Service Bulletin

Bulletin No.: 19-NA-074

Subject: Rotor Tinnerman Push Nut Removal Requirement for Accessory Wheel and Tire Installation

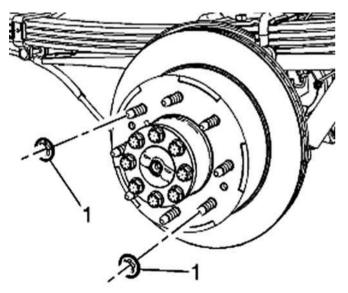
Prior to installing affected Accessory wheels, the dealer technician must remove and discard the tinnerman push nuts (1). Failure to do so may result in unintended lug nut and wheel loosening.
